CITY PLAN COMMISSION

FILE NUMBER: S245-115

LOCATION: Valley Creek Drive, north of Spring Valley Road

REQUEST: An application to replat a 1.33-acre (57,852.87-square foot) tract of land containing all of Lots 1 and 2 in City Block 8/8186 to create one lot on property and to reduce a portion of an existing 40-foot building line by 4.38 feet for the distance of 16.20 feet along Valley Creek Drive on property located on Valley Creek Drive, north of Spring Valley Road.

1:2,400	<p>EXISTING AREA ANALYSIS MAP</p> <p><input type="checkbox"/> Area of Request</p> <p><input type="checkbox"/> Recent History</p>	Case no: S245-115 Date: 3/3/2025
--	---	---

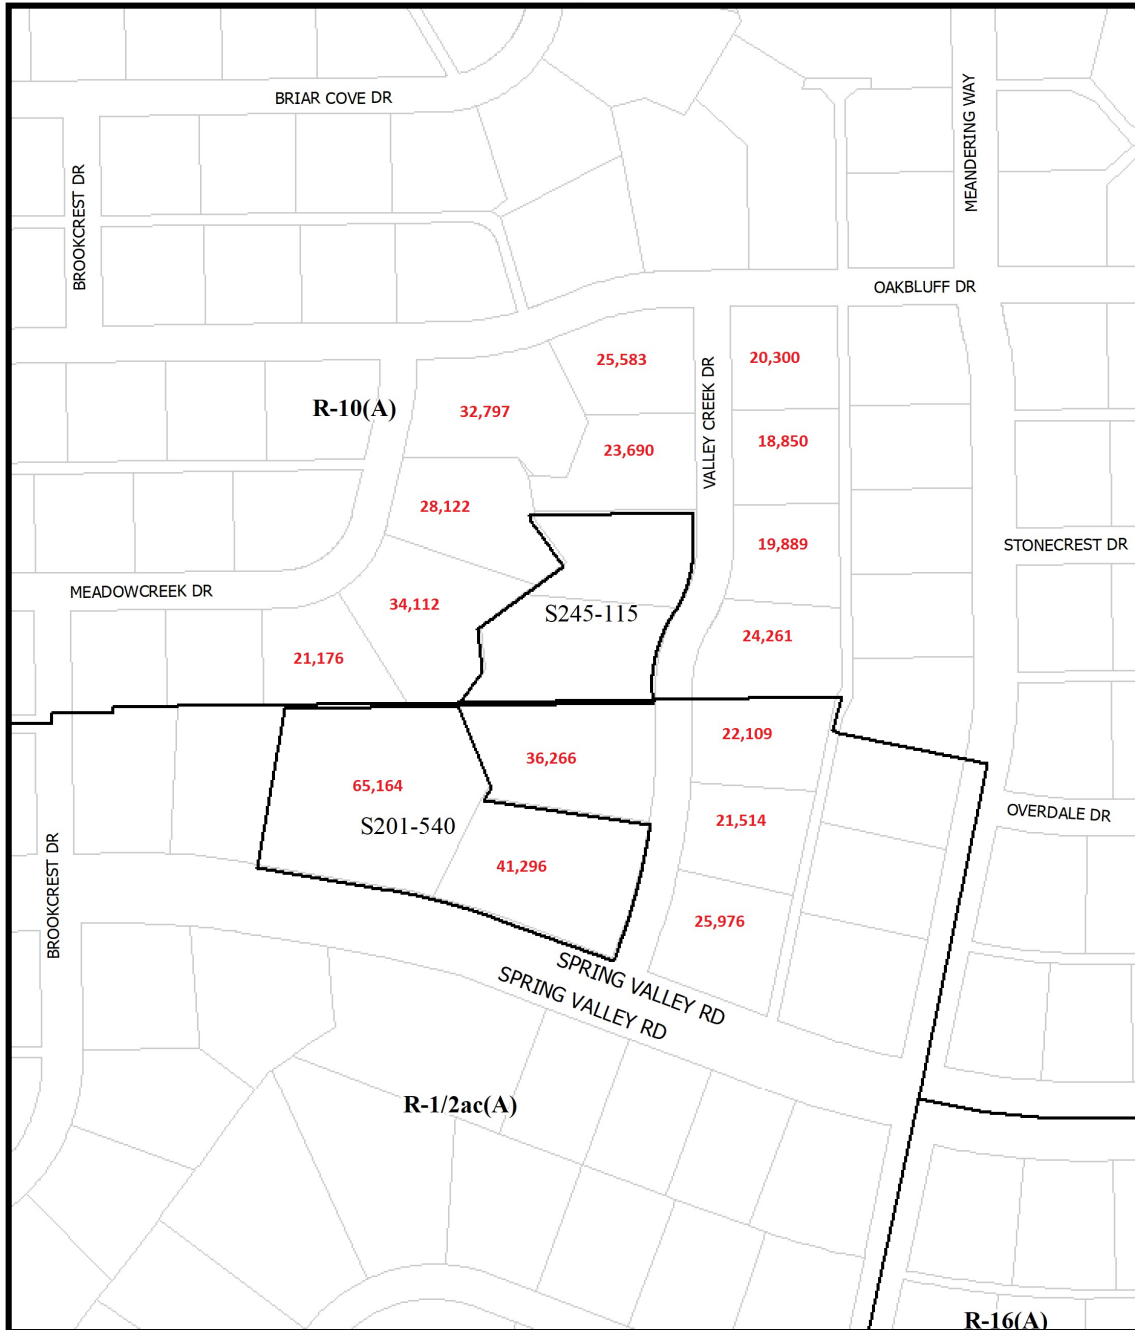
- The properties to the north, east, south, and west of the present request have areas ranging in size from 18,850 square feet to 65,164 square feet and are zoned R-10(A) Single Family District and R-1/2ac(A) Single Family District. *(Refer to the existing area analysis map).*
